Access Compliance Report

Public Rights-of-Way

Intersection ID: 12412	Main Street: BELMONT_AV	Cross Street: PEGRAM_ST	Location:	N
ADA ID: 799794E01261	Ramp Type: PerpDiag	Initial Pass/Fail: Fail	Overall Compliance: No	Severity Score: 10

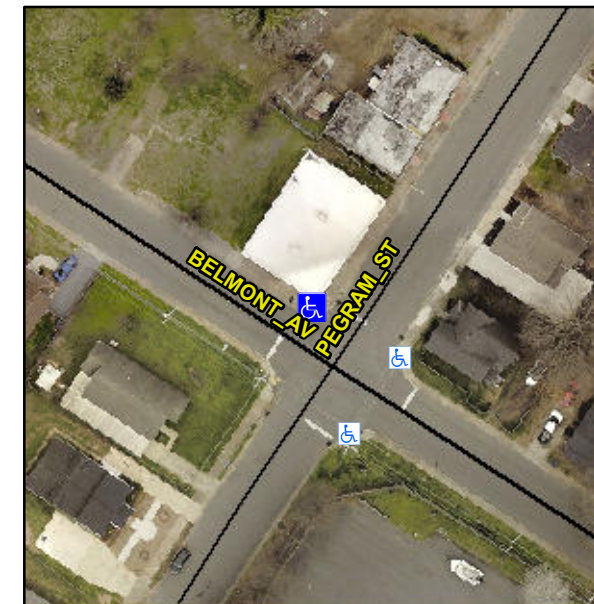
Not Found, R304.5.1, R304.5.3

Compliance	Description	Data	Compliance	Description	Data
N/A	Ramp Length (in)	24.0	Yes	Ramp Slope (%)	5.1
No	Ramp Width (in)	41.0	No	Ramp XSlope (%)	2.5
N/A	Flare Type LT	N/A	N/A	Flare Type RT	N/A
N/A	Flare Slope LT (%)	N/A	N/A	Flare Slope RT (%)	N/A
N/A	Flare Traversable LT?	N/A	N/A	Flare Traversable RT?	N/A
N/A	Landing Length (in)	N/A	N/A	DWS Provided?	N/A
N/A	Landing Width (in)	N/A	N/A	DWS Contrast?	N/A
N/A	Landing Slope (%)	N/A	N/A	DWS Length (in)	N/A
N/A	Landing X Slope (%)	N/A	N/A	DWS Full Width?	N/A
N/A	Landing Curb? (Y/N)	N/A	N/A	DWS Offset (in)	N/A
N/A	Shared Landing?	N/A			
N/A	Gutter Ponding?	N/A	N/A	Gutter Slope (%)	N/A
N/A	Gutter Lip Ht (in)	N/A	N/A	Gutter X Slope (%)	N/A
N/A	Painted X Walk1?	No	N/A	Painted X Walk2?	No
	X Walk 1 Direction	To SW		X Walk 2 Direction	To SE
N/A	X Walk 1 Width (in)	N/A	N/A	X Walk 2 Width (in)	N/A
	X Walk 1 Slope (%)	2.4		X Walk 2 Slope (%)	3.5
	X Walk 1 X Slope (%)	1.0		X Walk 2 X Slope (%)	1.6

Remove & Replace Curb Ramp With Two New Directional Ramps or Equivalent.
